Hydrology and Earth System Sciences

Inclusion of flood diversion canal operation in the H08 hydrological model with a case study from the Chao Phraya River Basin – Part 1: Model development and validation (hess-2021-532)

COMMENTS FROM EDITOR

Comments from Reviewer #2:

Figure 1. Observed canal discharge for different canal systems during the wet season of 2016.

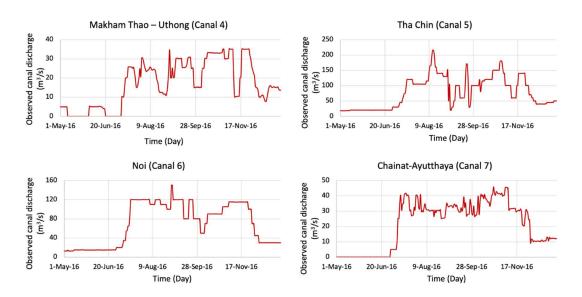
2. According to the Eq. 2, there may be a jump of D_wet (from Q_min to Q- Q_env) when the Q is reaching the Q rivcap. Is it what you expected?

Thank you very much for your valuable comment. It is true that there will be a jump in the daily D_{wet} values from Q_{cancap} to Q_{min} when the river discharge falls below the Q_{rivcap} . There will be another jump in D_{wet} values from Q_{min} to $Q-Q_{env}$ when river discharge is approaching the environmental flow. However, this pattern of sudden changes in canal flow was also seen in the observed canal diversion flow values (please see the below figure for reference). We tried to replicate this observed pattern using the proposed canal operations.
